NSP MONTICELLO NUCLEAR GENERATING PLANT

ANSWERS TO DRL QUESTIONS
OF JUNE 3, 1971

ANSWERS TO
DRL QUESTIONS OF JUNE 3, 1971
MONTICELLO OFF-GAS MODIFICATION

FIGURE 1

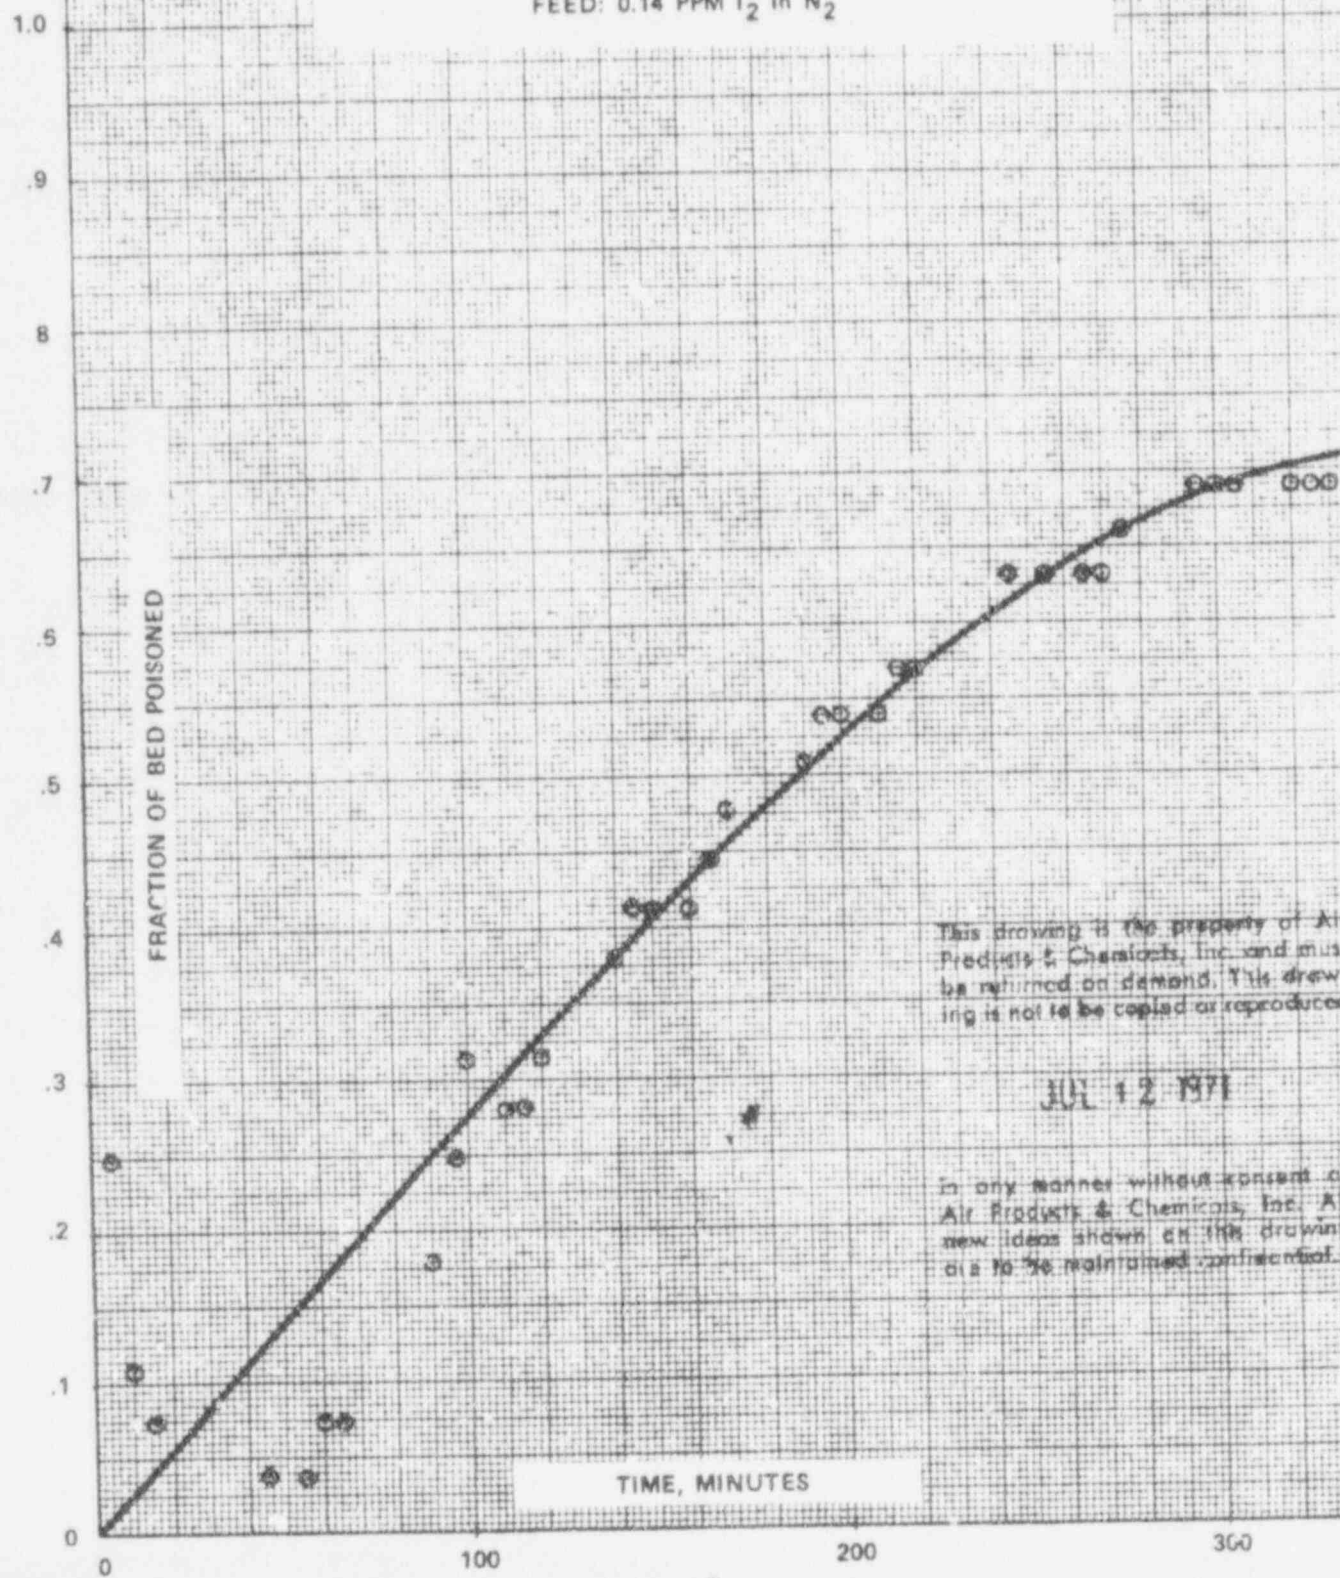
1. b. You will provide us with data on the operation of the recombiner using BWR effluents (including trace amounts of iodine).

Figure 1 illustrates the cumulative poisoning effect of 0.14 ppm of iodine in the feed. The fraction of the bed poisoned was determined using the measured inlet and outlet concentrations of oxygen and calculating the required bed depth to achieve these conversions. The difference between the required bed depth and the actual bed depth was that portion of the bed which was poisoned.

The above descriptions are illustrated in the attached drawing, NF-54812.

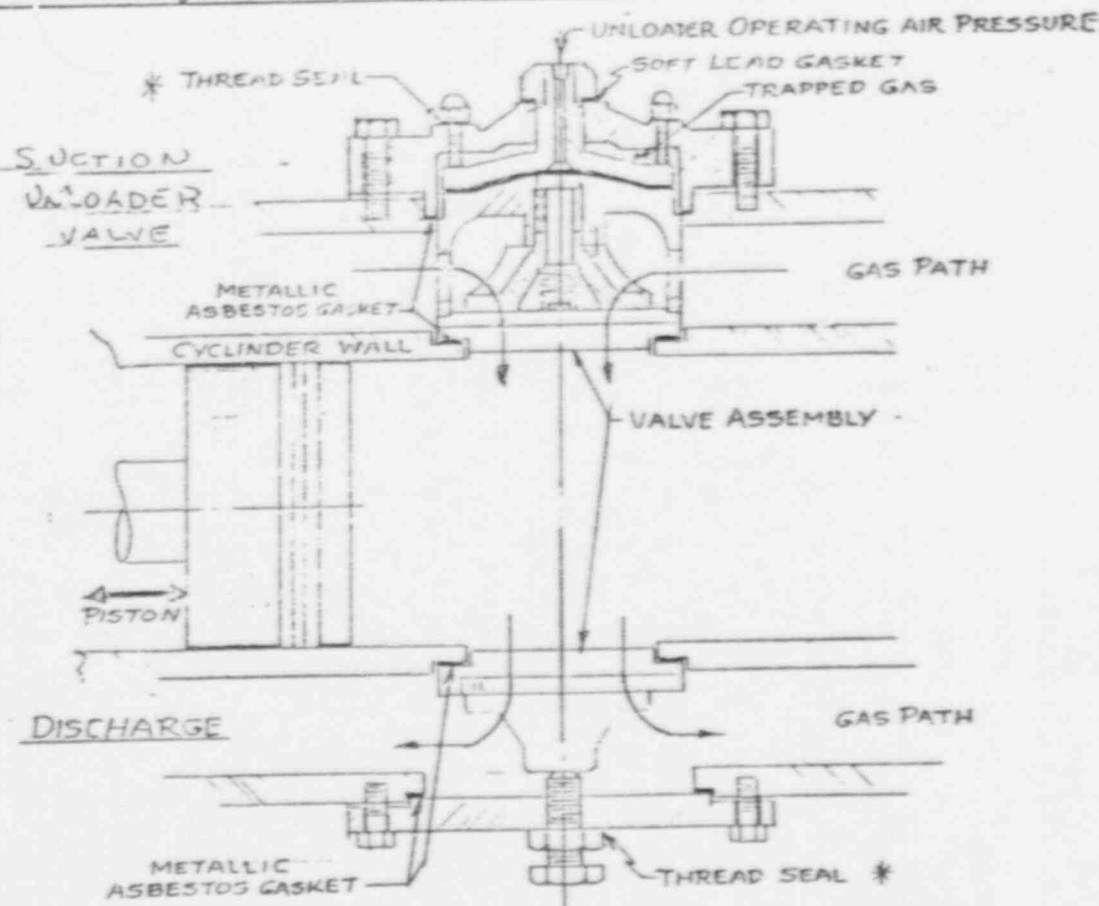
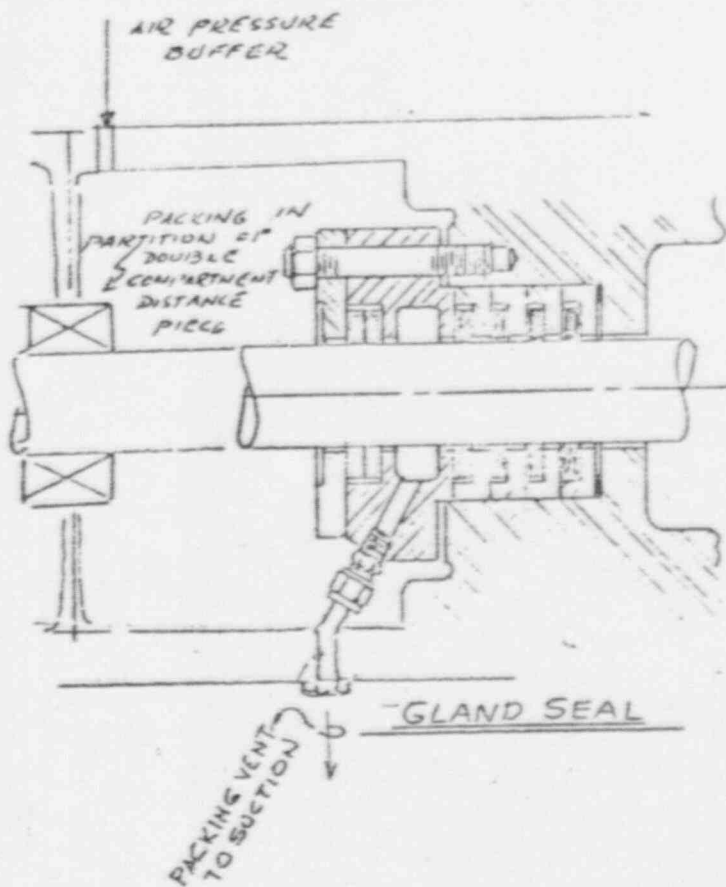
9. Provide the design details of the proposed gas compressors that will provide capability for essentially zero leakage. What type of valves will be used and what is expected leakage through the stem?

A civil plot plan, Northern States Power Co. drawing NF-51144, is submitted herewith in response to the above comment.

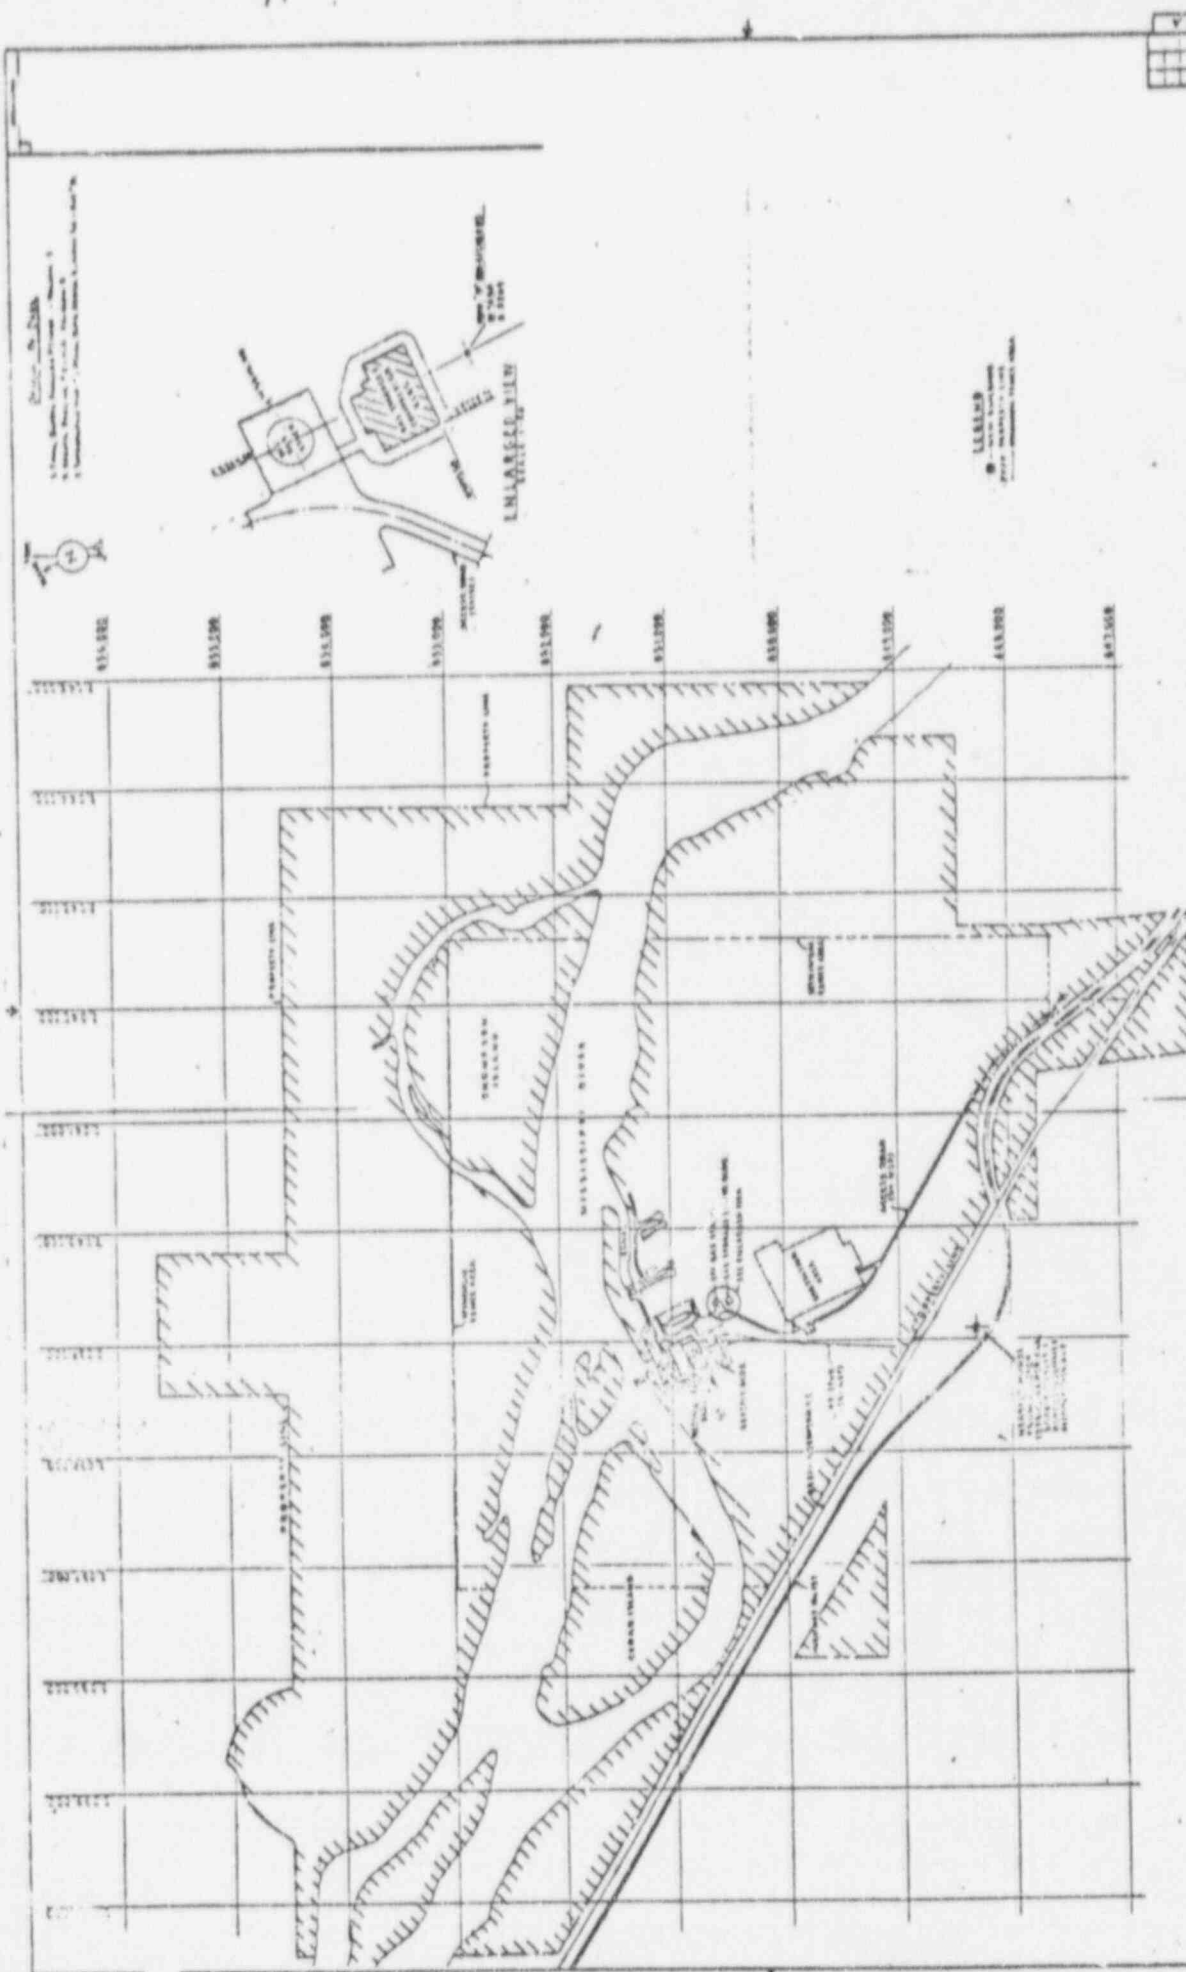
13. Provide a scaled plot plan indicating the location of the proposed facility relative to the stack, site property boundary, restricted area boundary, the exclusion radius, and the nearest residence.
